SUNDRY NOTICES AND REPORTS ON WELLS
Do not use this form for proposals to drill or to re-enter an abandoned well. Use form 3160-3 (APD) for such proposals.

1 Type of Well ☐ Oil Well ☐ Gas Well ☒ Other INJECTION		5 Lease Serial No. NMLC065151
2 Name of Operator DUGAN PRODUCTION CORP		6 If Indian, Allottee or Tribe Name
3a Address P O BOX 420 FARMINGTON, NM 87499-0420		7 If Unit or CA/Agreement, Name and/or No.
3b Phone No (include area code) Ph. 505-325-1821		8 Well Name and No BILBREY 51 1
4 Location of Well (Footage, Sec., T, R, M, or Survey Description) Sec 23 T9S R37E NENE 660FNL 660FEL		9 API Well No 30-025-24321
		10 Field and Pool, or Exploratory SWD; SAN ANDRES
		11 County or Parish, and State LEA COUNTY, NM

Operator plans to plug the well as follows:

OPERATOR Dugan Prod Corp
WELL Bilberry 51-01
API NO. 3002524321
Sec 23 TWN 9S RNG 37E
660 NS 660 EW 1/4 1/4 NENE

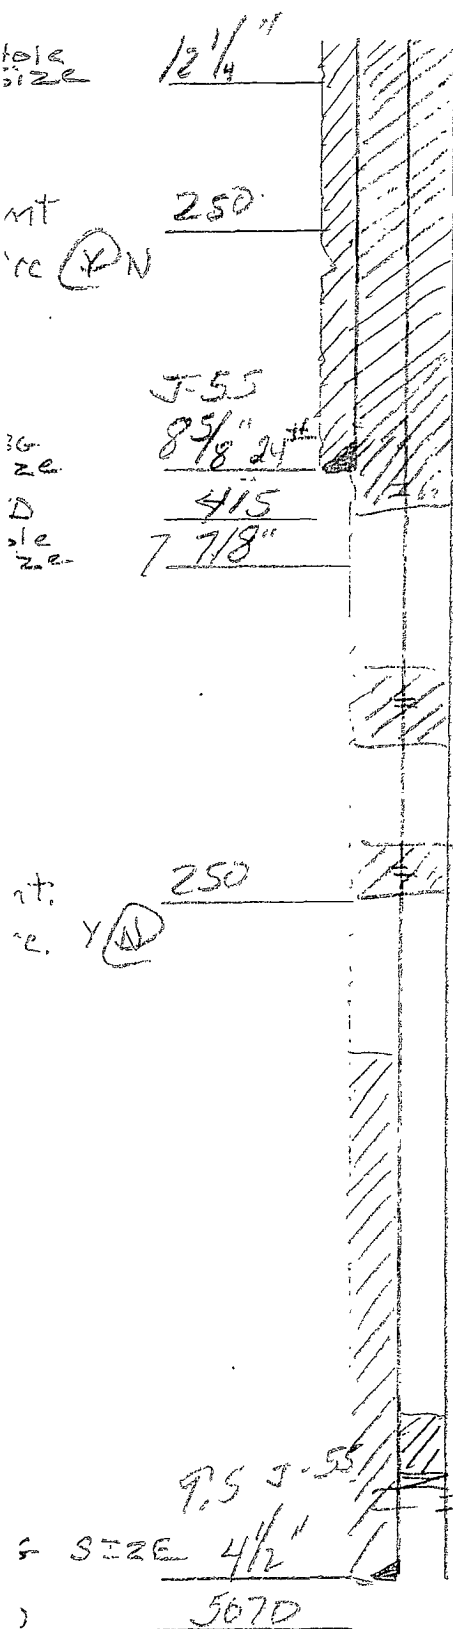
SPECIAL: T/SALT 2355 +/-
B/SALT 2805 +/-
R IIIIP _____
Cave/KARST _____

Perf @ 2400, 502 cnt
to 2280 WDC Tag

Perf @ 2855 - 502
cnt f to 2735 WDC Tag

CIBP 4840 Cap w/ 25 SA cnt

Accepted as to plugging of the well bore.
Liability under bond is retained until
Surface restoration is completed.

Ground Level Dry Hole Marker Required
